Notice of Petition for Waiver of Felix Storch, Inc. (FSI) From the Department of Energy Commercial Refrigerator, Freezer and Refrigerator-Freezer Test Procedure, and Grant of Interim Waiver

ACTION: Notice of petition for waiver, notice of grant of interim waiver, and request for comments.

RE: *Application for Interim Waiver pursuant to 10 C.F.R. § 431.401 for basic Summit models:* SCF694, SCF695S, SCF1094, SCF1095S, SCF1494, SCF1495S, SCF1694, SCF1695S, SCF1894, SCF1895S, SCF630, SCF940, SCF1310, and SF1710

ATTACHMENT C

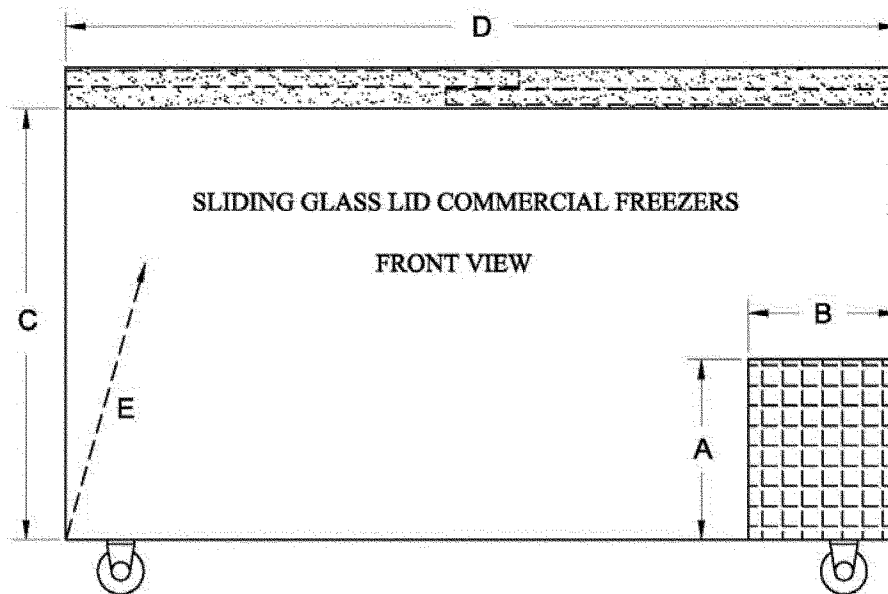
All self-contained horizontal storage freezers contain a compressor, which is generally mounted on one side of the freezer near the bottom. Some manufacturers place the inner “floor” of the freezer at a level flat across the top of the compressor housing. This is simpler and cheaper to manufacture because it requires only a rectangular inner cabinet. This construction has the same total display area as more expensive freezers that provide for a compressor step. Flat bottom freezers have a smaller volume, allowing for manufacture with smaller components, and thereby resulting in a lower price. All the FSI Freezers have a more expensive construction, which extends the interior to the floor (except for the compressor section).

Because energy usage is a function of overall volume, rather than top cross sectional area, it is reasonable to incorporate an adjustment factor to properly account for deeper, more voluminous freezers. While FSI, as a small business, is not in a position to survey the entire industry, FSI can document, for example, that 28% of the volume of the SCF1094 Freezer is below the compressor height step.⁸ It would be justified to apply an adjustment factor to account for the 28% higher energy usage for that model as compared to a flat bottom freezer with the same TDAs. Under current regulation both freezers are subjected to the same allowed maximum energy usage because the TDAs are the same.

ATTACHMENT D

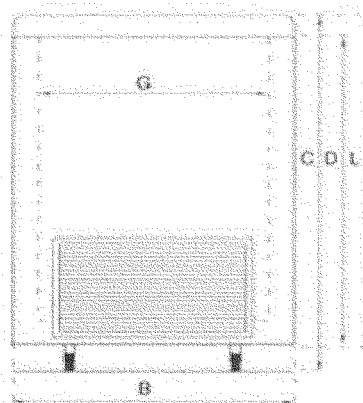
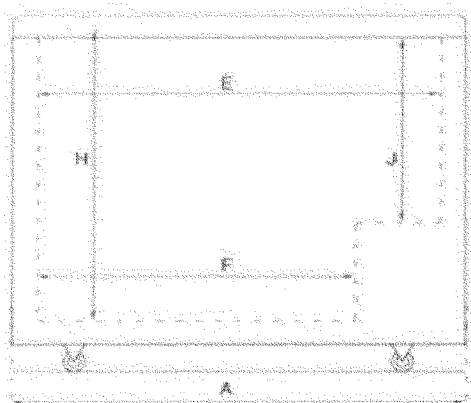
SCF1094 CALCULATION OF AREA
BELOW COMPRESSOR STEP
(REFER TO DIAGRAM)

$$3.482/12.3 = 28.3 \%$$
